# UNITED STATES PATENT AND TRADEMARK OFFICE

<b>Office Action Summary</b>	Application No. 10/796,450	Applicant(s) WILSON, DAVID G.	
	Examiner Courtney Thomas	Art Unit 2882

**DETAILED ACTION*****Drawings***

5. **Figure 1 - Cephalometric Radiology Apparatus - U.S. Patent 5,454,023 to Asikainen**

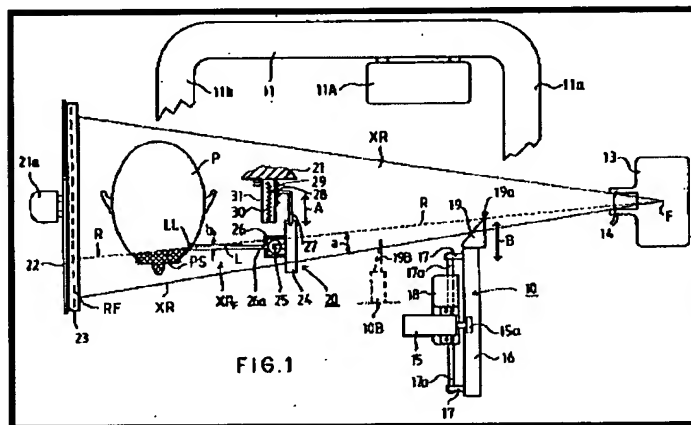
6. As per claims 1, 13, 14, 20, 21, Asikainen discloses an apparatus (and corresponding method of use) comprising: an X-ray generator (13); an X-ray detector (23); a support structure (12-not shown above); a collimator (14); a soft tissue filter (19), wherein the soft tissue filter screen is independently adjustable relative the collimator (14); and a mounting component (10)

17. **As per claims 15-17, 32 and 33**, Asikainen as modified above, discloses an apparatus further comprising at least one positioning light (25) to identify an optimum position of the soft tissue filter screen (see Fig. 1, above; see also column 3).
